# Access Compliance Report

## Public Rights-of-Way

### (Pedestrian Signals)

Intersection ID: N/A	Main Street:	Cross Street: N/A	Location: N/A
ADA ID: 70447BD09704	Signal Type: One Push Button-Non APS	Overall Compliance: No	Severity Score: BTN 1: N/A BTN 2: N/A No BTN: N/A
Codes/Mitigation Info/Possible Solution		Field Measurements/Component Compliance

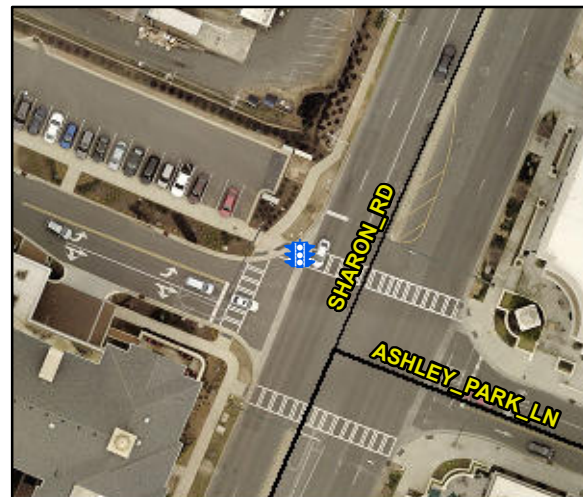
PROW/ADA: TMUTCD 4e.08, R404.2, R404.3, R406.2

Compliance	Description	Data	Compliance	Description	Data
	Button Count	Button1	Yes	Distant to Additional Button (in)	168.0
	Additional Button Present?	Yes		Additional Button ID	2AC2DAF21581
N/A	Signal Buttons Required?	N/A	N/A	Additional Ped Posts Required	N/A
	How Many Ped Street Xings?	1		Located In An Island/Median?	No
N/A	B 1 Sign Present?	Yes	N/A	B 2 Sign Present?	N/A
Yes	B 1 Sign Purpose?	Yes	N/A	B 2 Sign Purpose?	N/A
Yes	B 1 Sign Lettering & Contrast?	Yes	N/A	B 2 Sign Lettering & Contrast?	N/A
Yes	B 1 Parallel To XWalk?	Yes	N/A	B 2 Parallel To XWalk?	N/A
Yes	B 1 PAR to Button?	Yes	N/A	B 2 PAR to Button?	N/A
Yes	B 1 PAR to XWalk?	Yes	N/A	B 2 PAR to XWalk?	N/A
Yes	B 1 Clear Floor Space?	Yes	N/A	B 2 Clear Floor Space?	N/A
N/A	B 1 FWD Approach?	Yes	N/A	B 2 FWD Approach?	N/A
N/A	B 1 FWD Approach Constrained?	No	N/A	B 2 FWD Approach Constrained?	N/A
No	B 1 FWD Approach Reach (in)	9.0	N/A	B 2 FWD Approach Reach (in)	N/A

N/A	B 1 FWD Approach Width (in)	N/A	N/A	B 2 FWD Approach Width (in)	N/A
N/A	B 1 FWD Approach Obstruction?	Yes	N/A	B 2 FWD Approach Obstruction?	N/A
N/A	B 1 FWD Approach Obstruction Dist (in)	5.0	N/A	B 2 FWD Approach ObstructionDist (in)	N/A
N/A	B 1 PARA Approach?	Yes	N/A	B 2 PARA Approach?	N/A
N/A	B 1 PARA Approach Constrained?	No	N/A	B 2 PARA Approach Constrained?	N/A
Yes	B 1 PARA Approach Reach (in)	9.0	N/A	B 2 PARA Approach Reach (in)	N/A
N/A	B 1 PARA Approach Width (in)	N/A	N/A	B 2 PARA Approach Width (in)	N/A
N/A	B 1 PARA Approach Obstruction?	Yes	N/A	B 2 PARA Approach Obstruction?	N/A
N/A	B 1 PARA Approach Obstruction Dist (in)	5.0	N/A	B 2 PARA Approach ObstructionDist (in)	N/A
No	B 1 Clear Floor Space Slope (%)	5.2	N/A	B 2 Clear Floor Space Slope (%)	N/A
Yes	B 1 Clear Floor Space XSlope (%)	0.6	N/A	B 2 Clear Floor Space XSlope (%)	N/A
N/A	B 1 PAR Slope (%)	0.2	N/A	B 2 PAR Slope (%)	N/A
Yes	B 1 Height (in)	39.0	N/A	B 2 Height (in)	N/A

Yes	B 1 Clear Xing Direction?	ClearlyMarked	N/A	B 2 Clear Xing Direction?	N/A
	B 1 Crossing Direction	To SE		B 2 Crossing Direction	N/A
Yes	B 1 DistanceTo XWalk (in)	0.0	N/A	B 2 DistanceTo XWalk (in)	N/A
No	B 1 DistanceTo Curb (in)	79.0	N/A	B 2 DistanceTo Curb (in)	N/A
Yes	B 1 Diameter (in)	2.0	N/A	B 2 Diameter (in)	N/A

Possible Solutions: Replace Signal Push Button With APS Button on New Post. Remove & Relocate Sign.
